SUPPLEMENTARY MEMO

DATE: 24 October 2023
TO: Development Determination Panel
CC: Rodney Piggott, Manager, Development Assessments
FROM: Claire Ryan, Principal Planner
SUBJECT: DA2023/0278 – 3 Pavilion Street, Queenscliff

At the lower ground floor level –

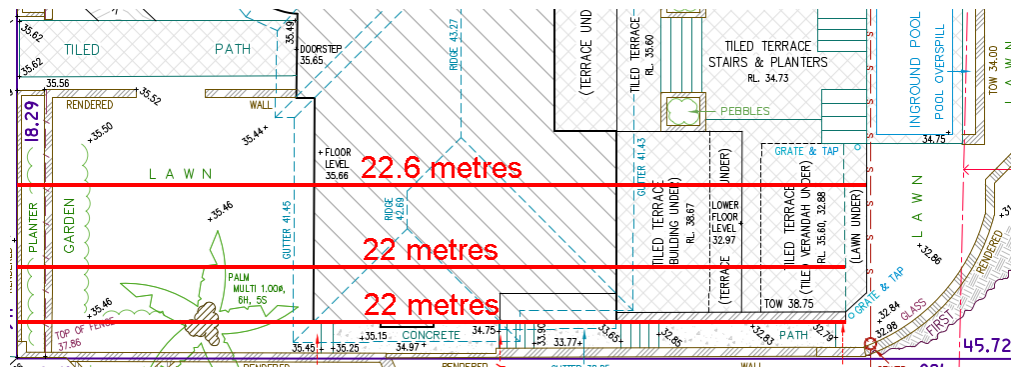
The Assessment Report states the proposed development “does not extend any further seaward beyond the existing built-upon footprint.” Mr Winton raised concern with this statement, noting that the south elevation shows amended walls to the lower ground and ground terraces, that the wall includes a door at the lower ground level, and that the works extend the building seaward. Mr Winton and Mr & Ms Dover reiterated dissatisfaction with this element of the proposed works, with respect to access to light to their properties.

- The existing terrace ends 22 metres from the front boundary.
- The proposed terrace extends to 23.6 metres from the front boundary.

The amended terrace and the proposed copper blade wall amounts to a seaward extension of 1.6 metres.

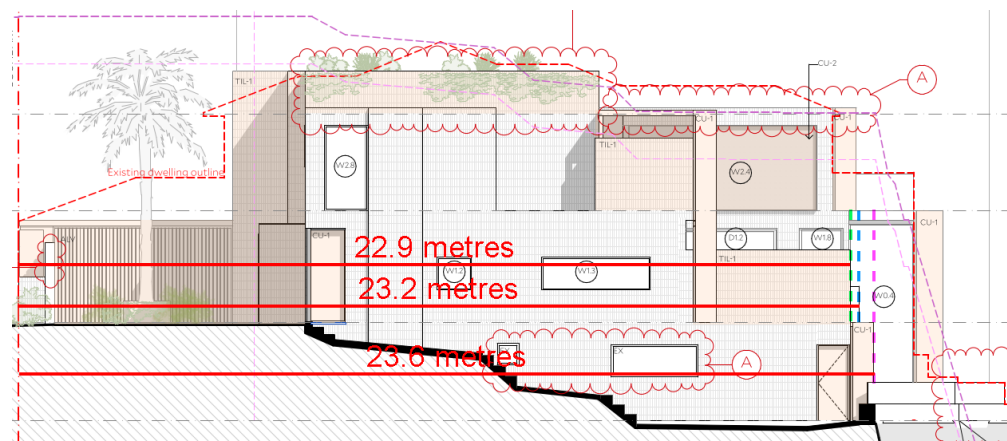
- The existing terrace ends 22.6 metres from the front boundary.
- The existing southern wall adjoining the terrace ends 22 metres from the front boundary.
- The proposed terrace extends to 23.2 metres from the front boundary.
- The amended southern wall adjoining the proposed terrace extends to 22.9 metres from the front boundary.

The amended southern wall is extended 900 millimetres and the amended terrace is extended seaward by 600 millimetres.

Above: The existing distance of the ground floor terrace (22.6 metres), lower ground floor terrace (22m) and southern wall (22m) from the front boundary.

Above: The proposed distance of the ground floor southern wall (22.9m), ground floor terrace (23.2m), and lower ground floor terrace with southern wall (23.6m) from the front boundary.

The incorrect statement that the development did not extend seaward arose from a comparison of the submitted demolition plans to the proposed plans. It was assumed that the demolition plans depicted the *existing* built form (which is common practice for demolition plans), but it was instead established that the demolition plans depicted the *proposed* built form.

Despite the seaward extension, no concern is raised regarding cliff stability, as the works are supported by a geotechnical report demonstrating acceptably low risk. The plans have been reviewed by Council's internal referral bodies, including the Development Engineer and Coast & Catchments Team. All referral bodies are supportive of the amended development, subject to conditions of consent, which have been included in the recommendation of the Assessment Report.

The proposed development is compliant with the requirements for access to sunlight set by Part D6 of the WDCP, and the portion of the development that concerns Mr Winton and Mr & Ms Dover is compliant with the applicable built form controls of both the WLEP and WDCP. As such, the proposed element in question is acceptable.
